Addendum Number 1

Date: June 3, 2026
Project: Veteran's Park Renovation Project
Owner: Willow Creek Community Services District

WILLOW CREEK VETERANS PARK

1 WILLOW CREEK SINGLE LINE DIAGRAM
L4.0

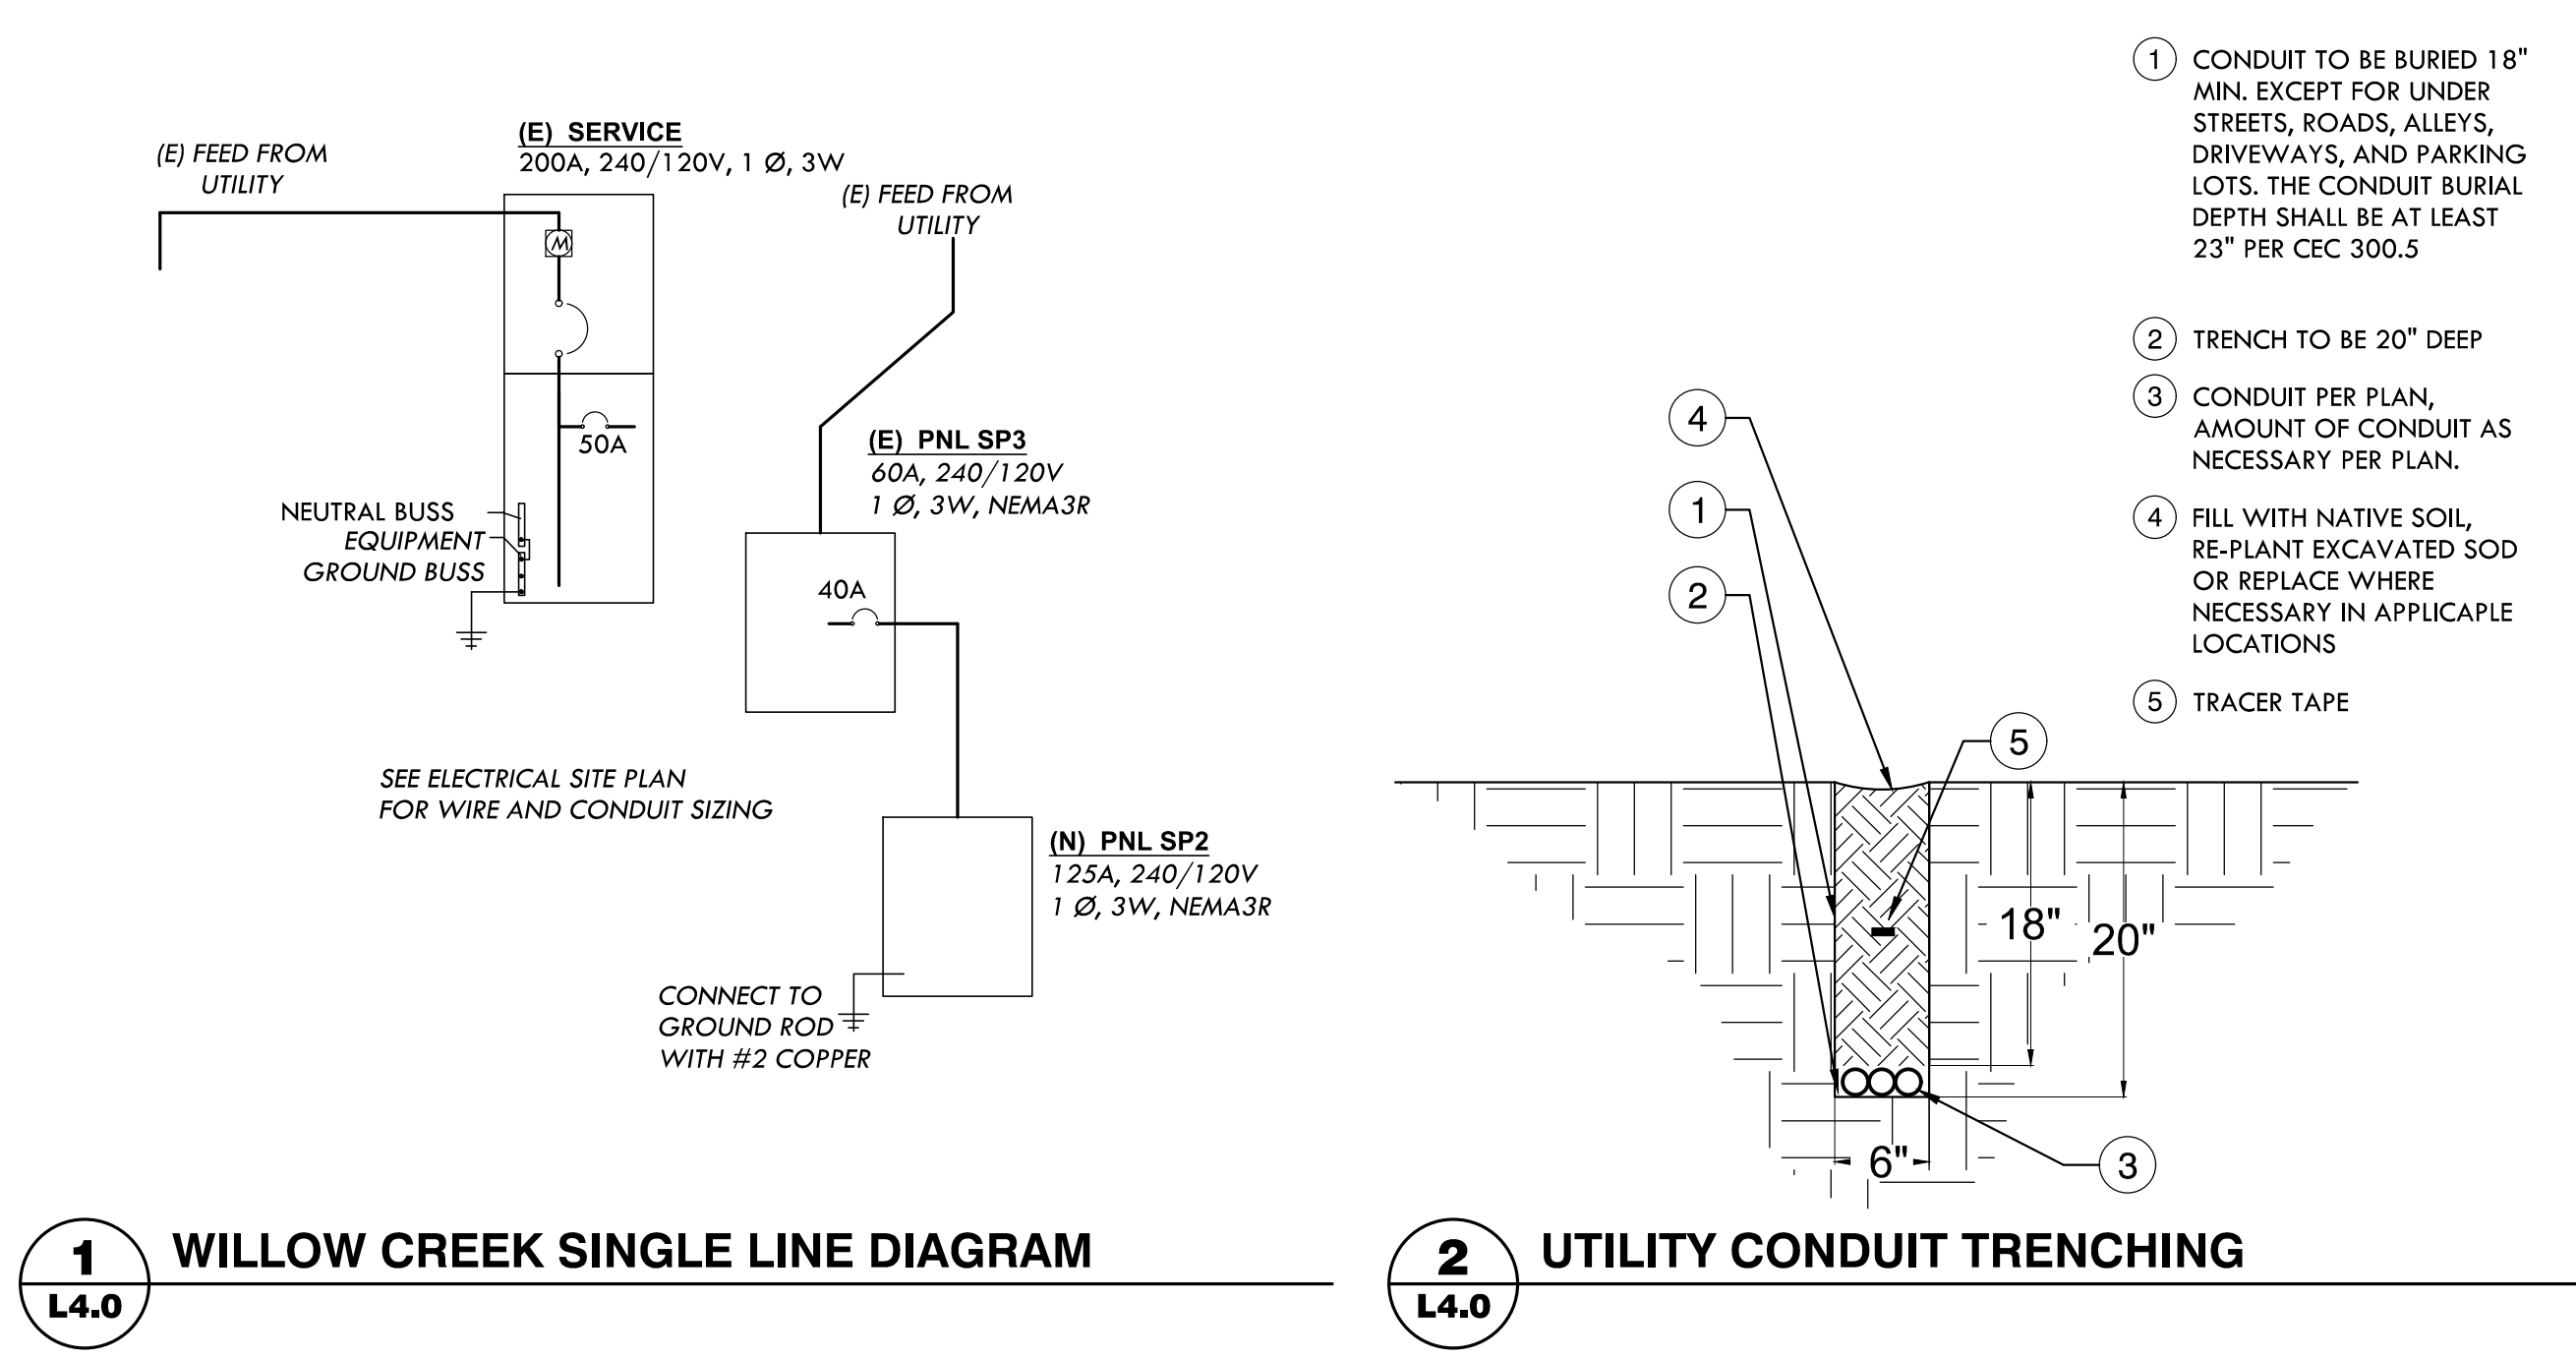
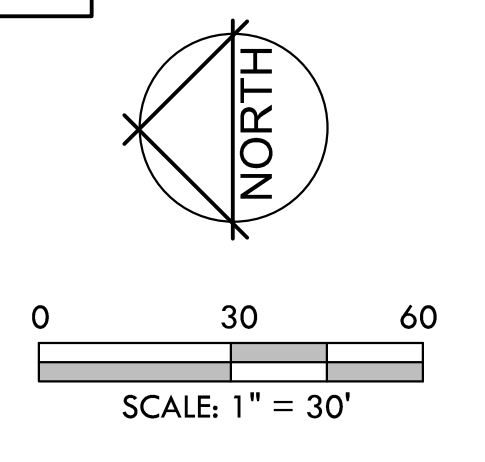
Change: See attached replacement sheet for sheet L4.0 and L4.1

16. Question about the connection from the new Panel 2 to the existing Panel 3.

Please refer to the changes shown on the replacement sheet L4.0 and L4.1.
